UNITED STATES PATENT AND TRADEMARK OFFICE

APPLICATION NO.	FILING DATE	FIRST NAMED INVENTOR	ATTORNEY DOCKET NO.	CONFIRMATION NO.
10/046,066	01/15/2002	David Tye	021878.0002US1	2831

<p>Office Action Summary</p>	Application No.	Applicant(s)	
	10/046,066	TYE, DAVID	
	Examiner	Art Unit	
	PAUL T. CHIN	3652

DETAILED ACTION

FIG. 4

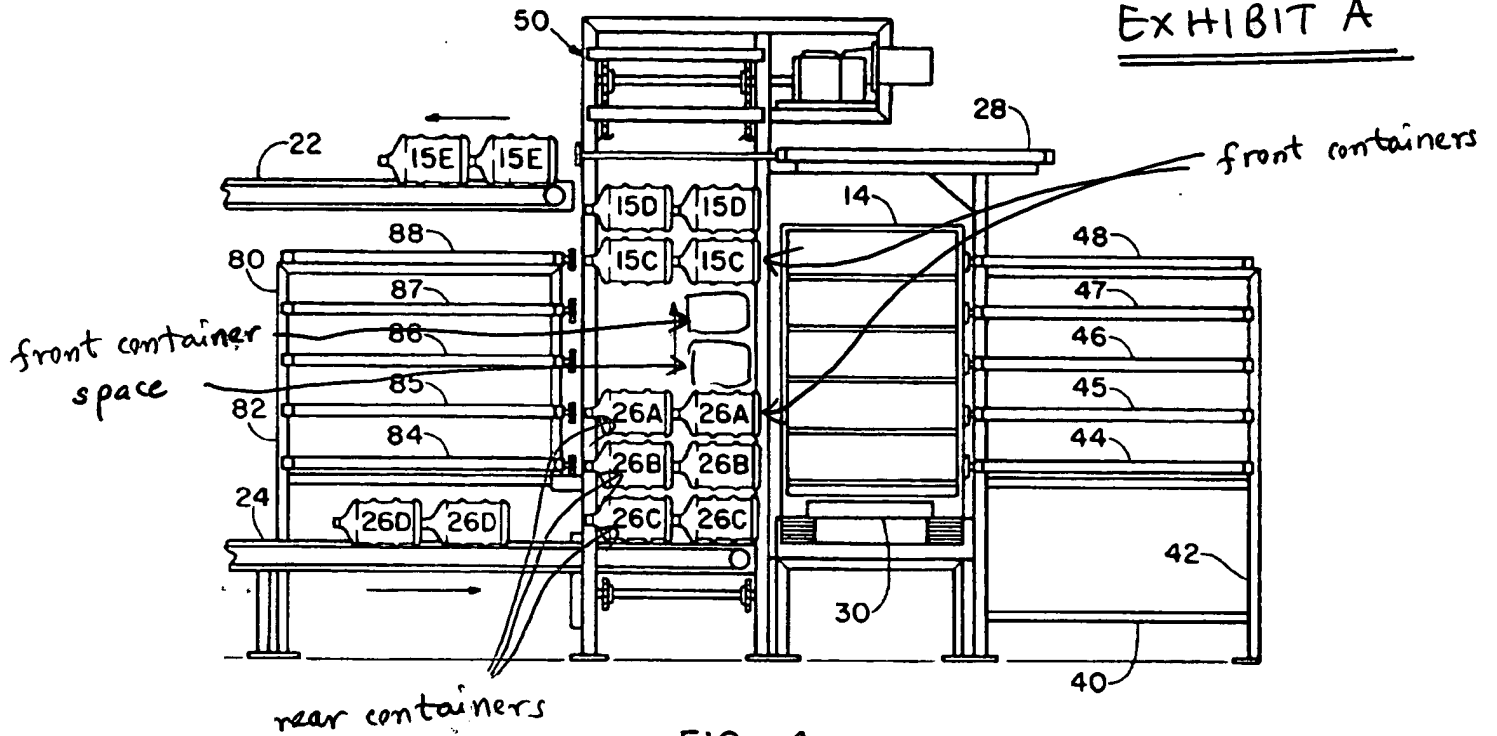
Simmons et al. (5,895,195) discloses a device for unloading a rack for storing containers, comprising a rack having a first space storing a front container (15C, 26A, 26B, 26C) (see Exhibit A, Fig. 4), a second space storing a rear container, the first container blocking the second container, the device having an extending arm (see Exhibit A) that extends through the front space into the rear space.

Re claim 23, the extending arm has an un-extended length (see Fig. 4) and a fully extended length (see Fig. 5).

FIG. 5

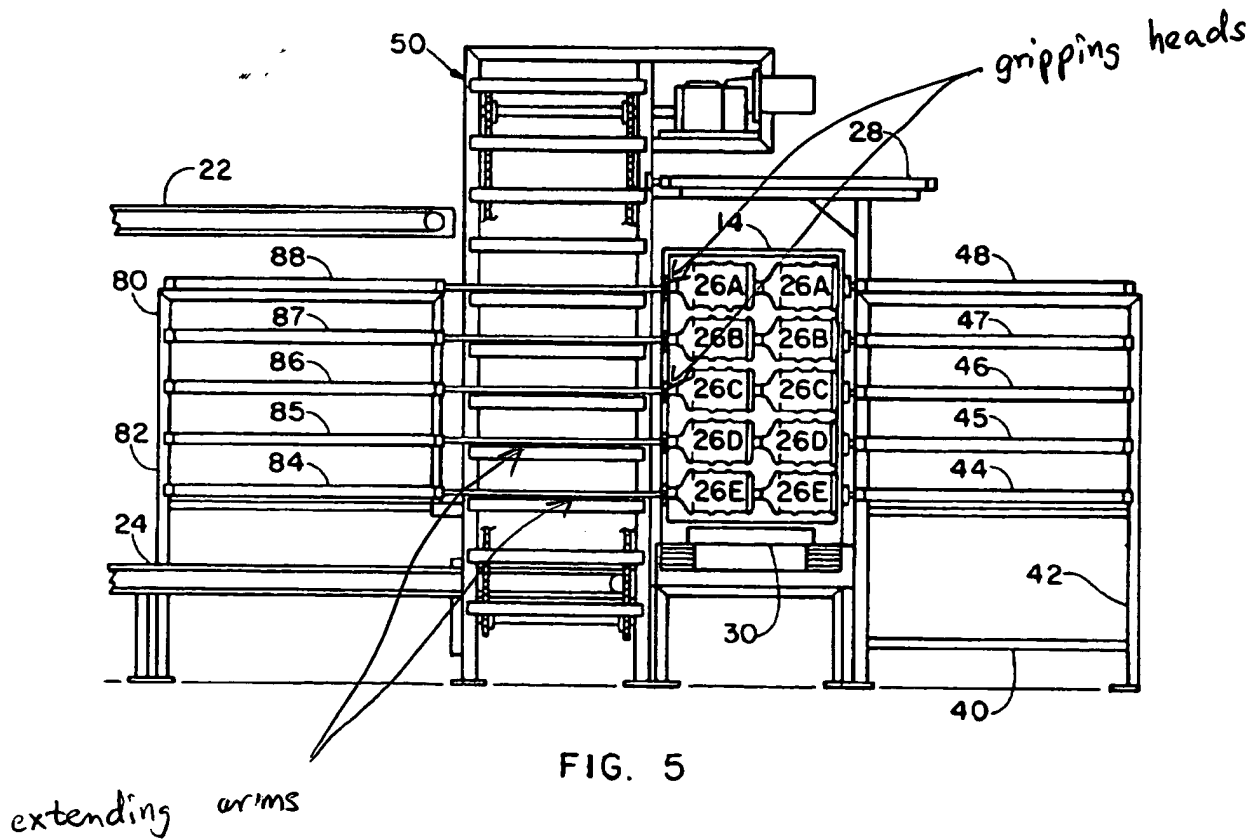
Tonjes (5,244,330) discloses a device for unloading a rack (22) and loading to another rack (14) for containers, comprising a rack having a first space storing a front container (see Exhibit B, Fig. 5), a second space storing a rear container, the first container blocking the second container, the device having an extending arm (74) (see Exhibit B) that extends through the front space into the rear space.

Re claim 23, the extending arm has an un-extended length (see Fig. 5) and a fully extended length.

FIG. 13

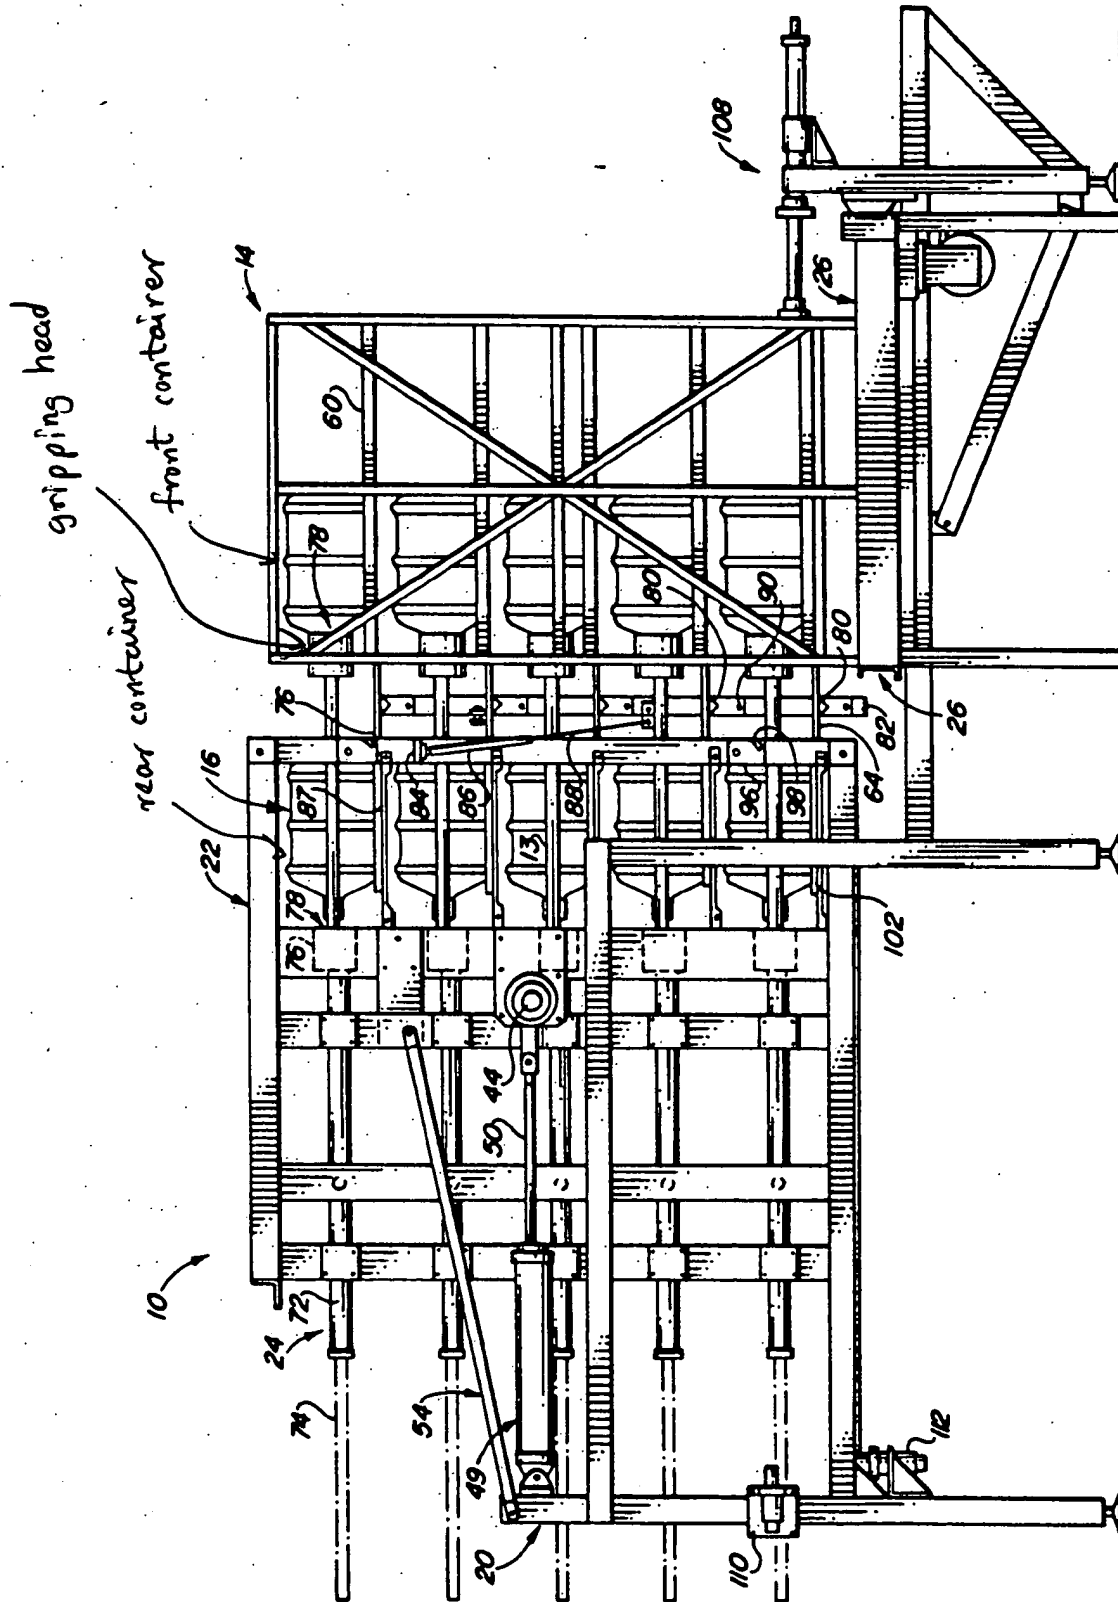
Butterly, Jr. et al. (4,634,33) discloses a device for unloading containers comprising a rack (see Exhibit C of Fig. 13) having a first space storing a front container (64), a second space storing a rear container, the first container blocking the second container, the device having an extending arm (51,57,54,61,56,62) that extends through the front space into the rear space. It is pointed out that the pushers can extend from the initial position (15A) to the final position (15C) (see Fig. 13) (Col 12, lines 3-31).

Re claim 23, the extending arm has an un-extended length (15A position) and a fully extended length (15C position).

EXHIBIT ①

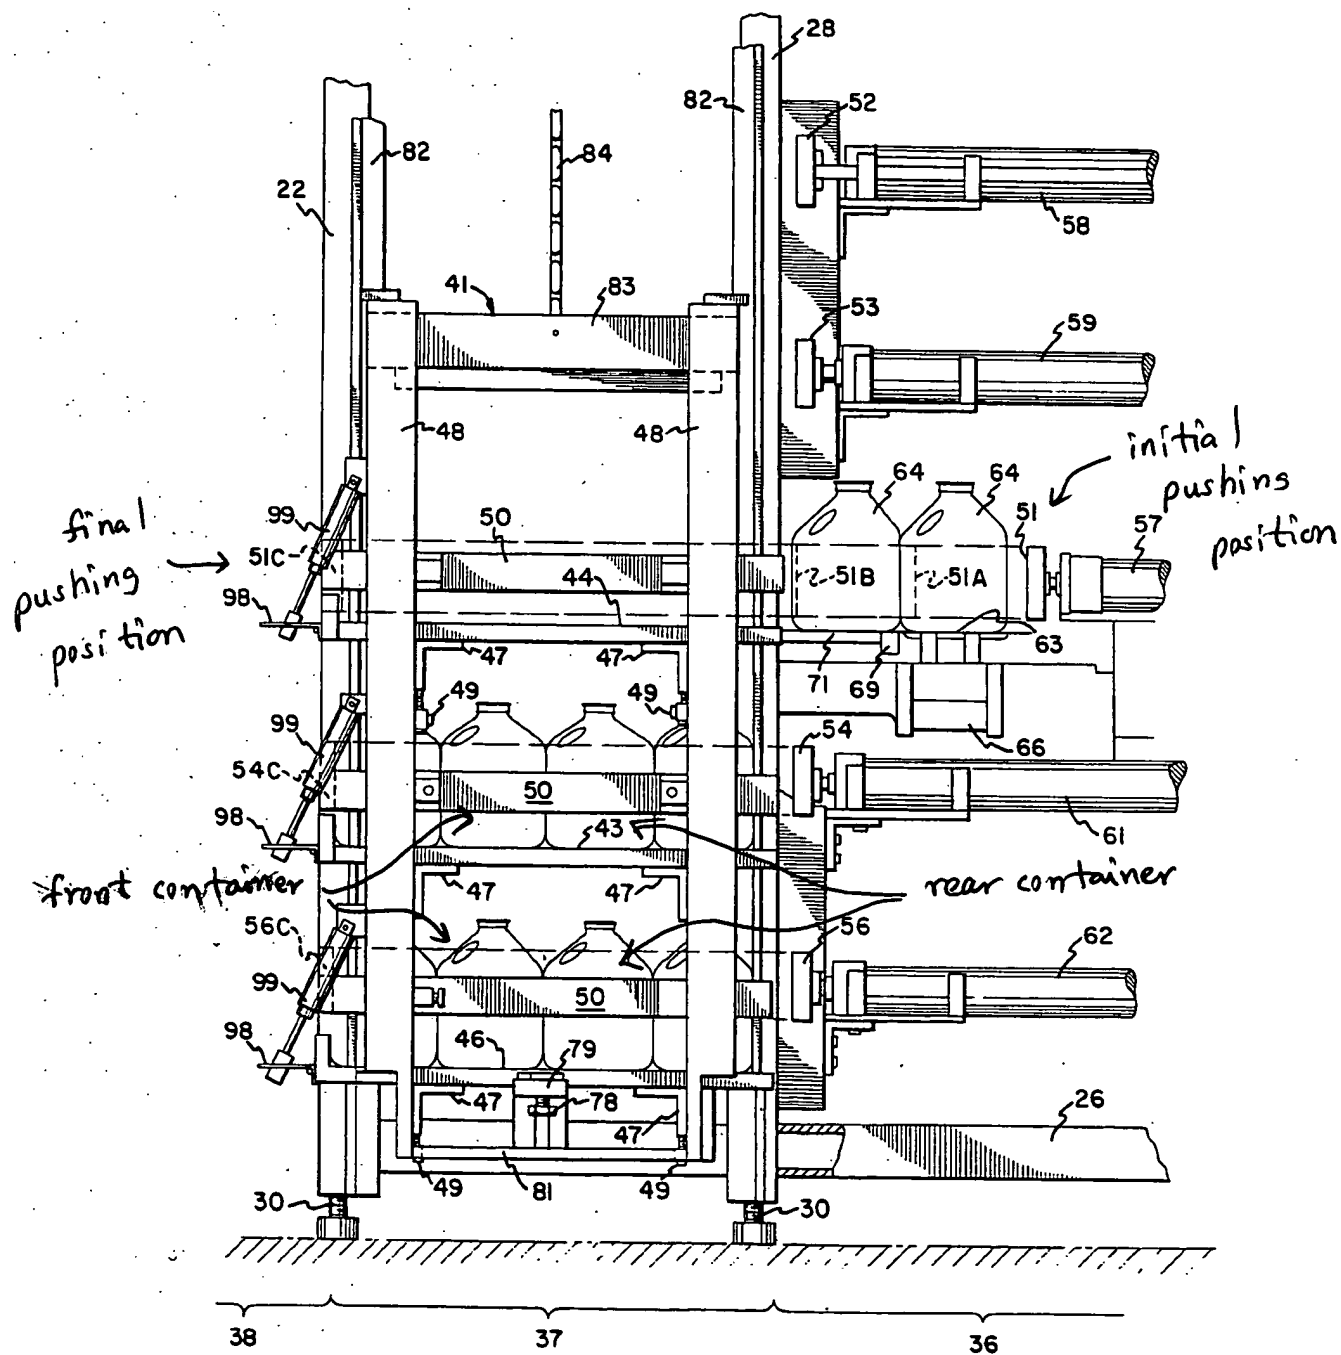
The European Patent (EP 0 534 558) discloses a device comprising a rack (1) having a first space storing a front container (see Exhibit D), a second space storing a rear container, the first container blocking the second container, the device having an extending arm (13) (see Figs. 5 and 6) that extends through the front space into the rear space.

Re claim 21, the extending arm has at least one gripping head (14,14) (see Fig. 4) that grips a container.

Re claim 23, the extending arm has an un-extended length (see Fig. 5) and a fully extended length (see Fig. 6).
